Subject: [External] Honeybrook Properties Amended Land Development Plan - 670 Birchrun Road

RE: Amended Land Development Plan
Honeybrook Properties, LLC
670 Birchrun Road
3rd LTL Review Letter

AS-BUILT SANITARY SEWER PLAN
AMENDED PRELIMINARY/FINAL LAND DEVELOPMENT PLAN
FOR
HONEYBROOK PROPERTIES, LLC

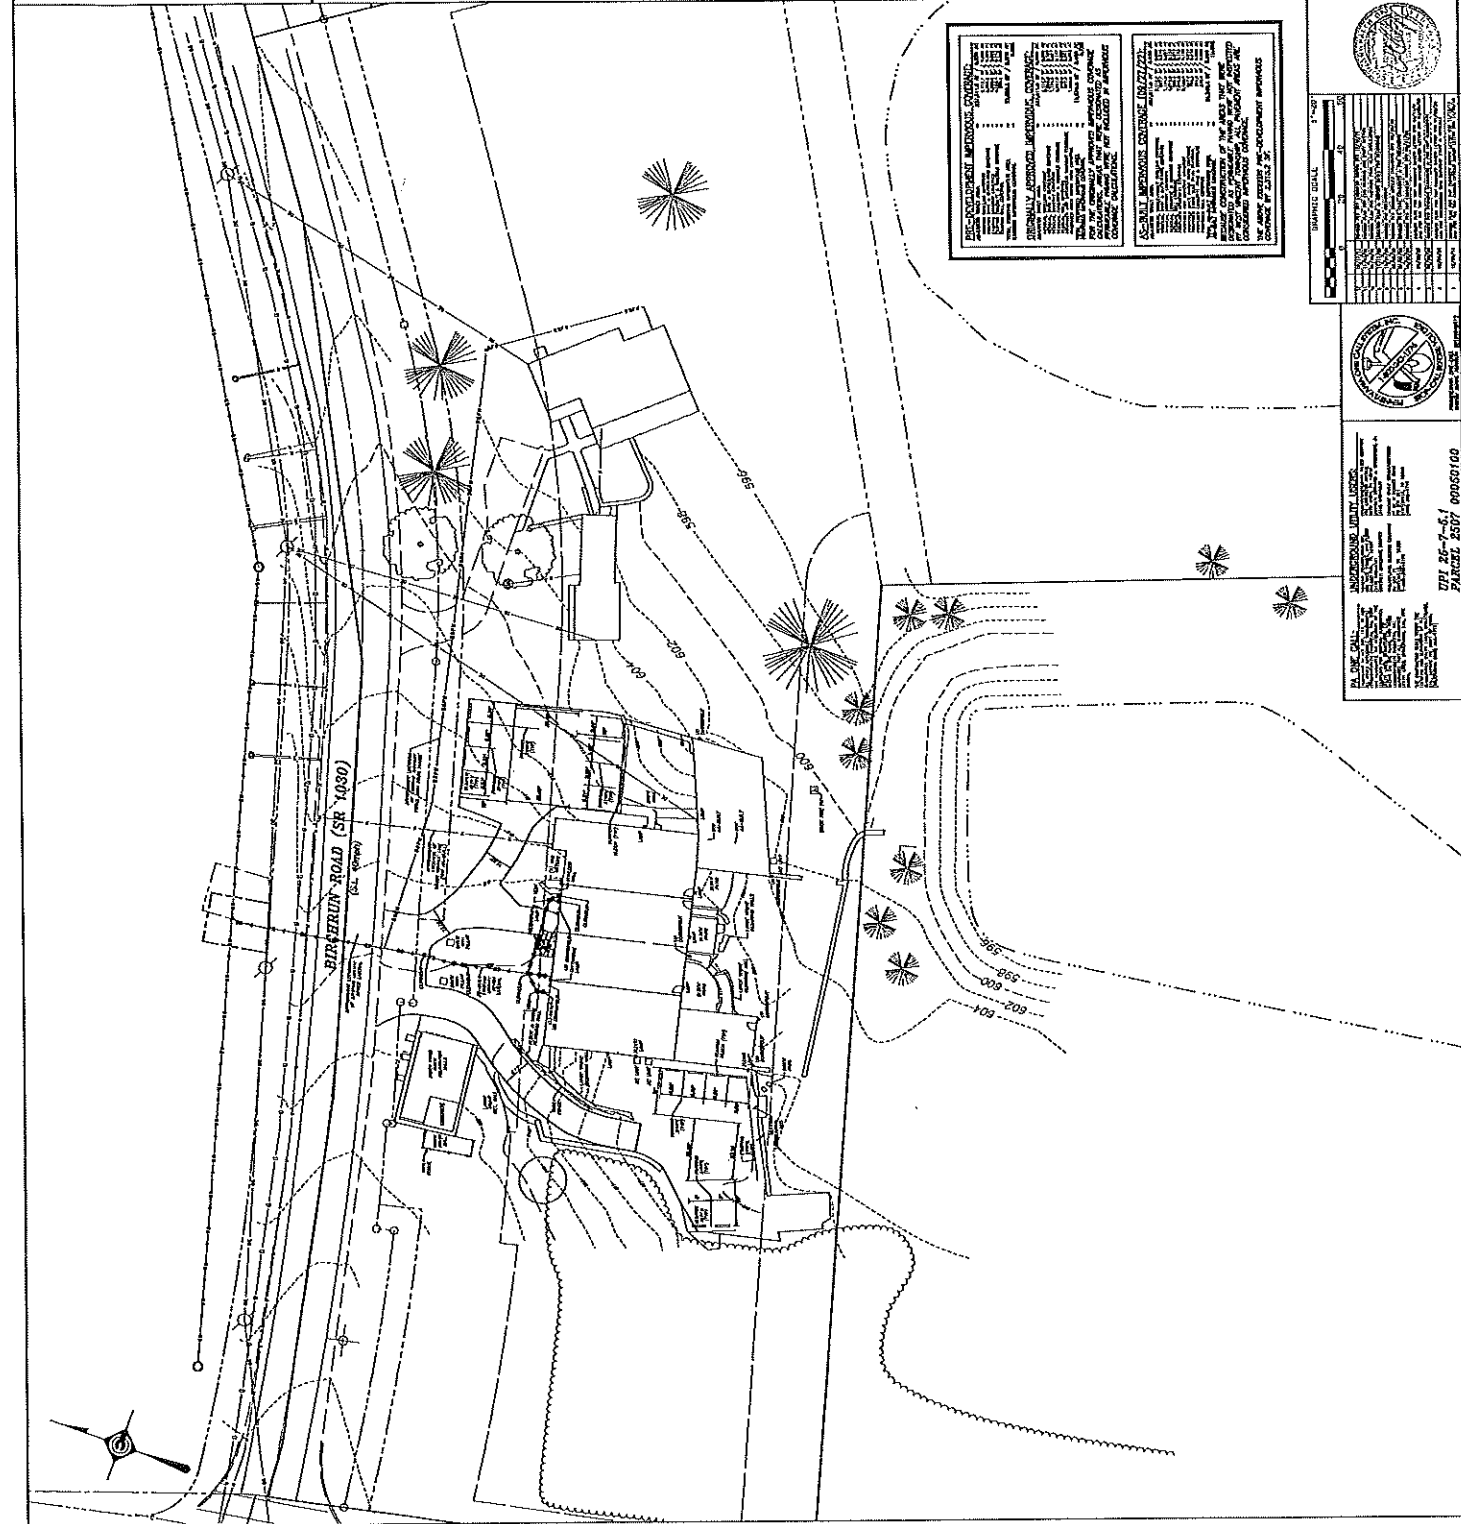
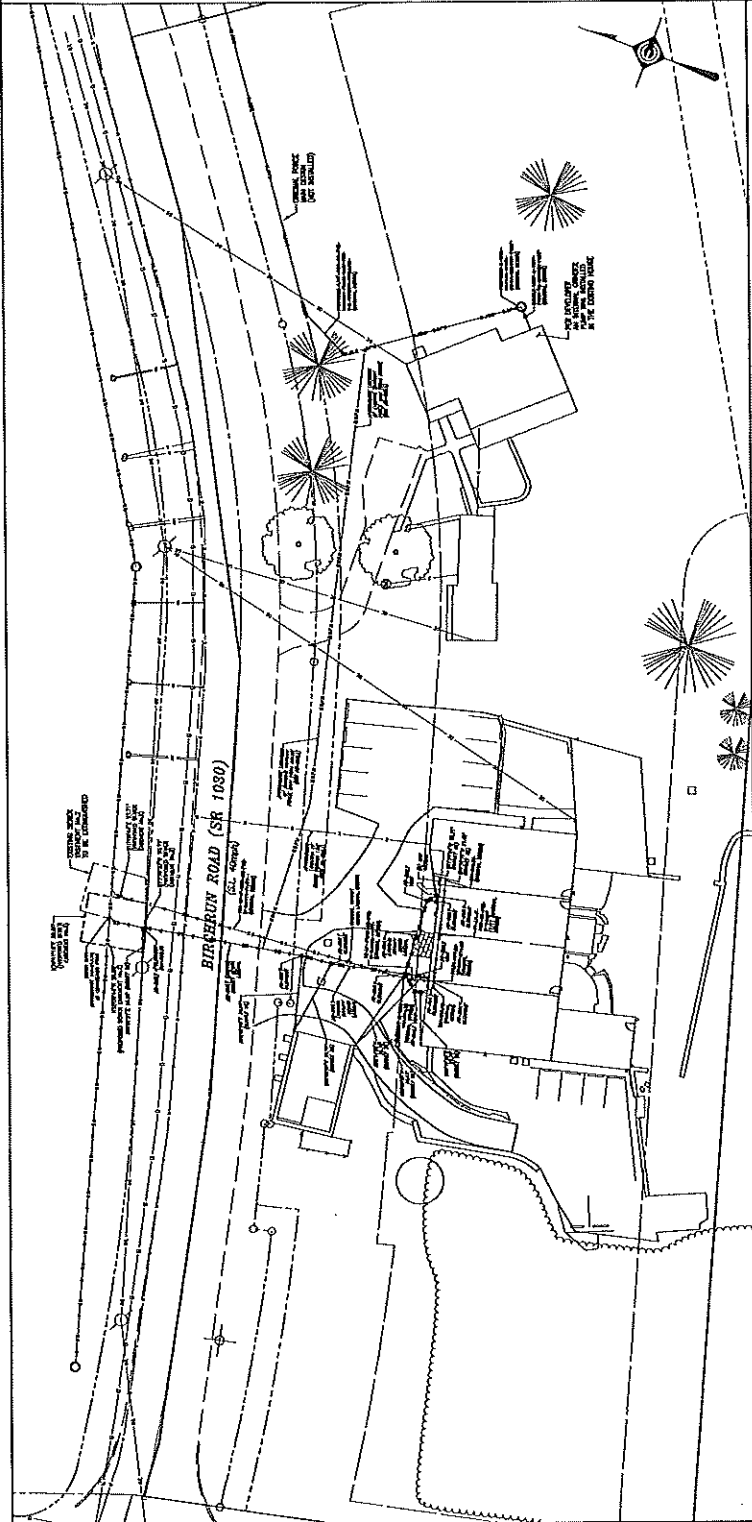
4. Subdivision & Land Development Ordinance Review Comments by LTL (Plan last revised 2/17/23)
- a) Plan Set – The Amended Plans still need to be revised to include final approved location of the sewage grinder pump and force main, as well as the trail location, details and metes and bounds. The plan set now includes eleven (11) sheets. Four sheets contain originally approved information including Sheets 1, 2, 3, and 8. Seven (7) new sheets are provided containing as-built survey information, parking and driveway layout revisions, stormwater design, erosion controls, additional landscape plants, and sanitary sewer information.

- 2) Sewage Facilities – Section 315-39 – Sewage facility construction did not comply with the originally approved plan. A fifth apartment unit in the former barn was connected to the lateral with a pump system. Also, the farmhouse grinder pump was installed inside the structure and the force main connected to the apartment building sewer lateral. The Bucks County Sewer and Water Authority and the Township Building Inspector are reviewing these land development plan nonconformities. The Applicant shall obtain written approval of the Amended Plan from both the Authority and Building Inspector. The Amended Plan shall be revised and approved by the Authority. The amended plan shall note in detail all sewer facilities to be abandoned or removed as well as any new facilities to be constructed. The new sewer easement on the Pulte Homes Property shall be obtained and recorded.
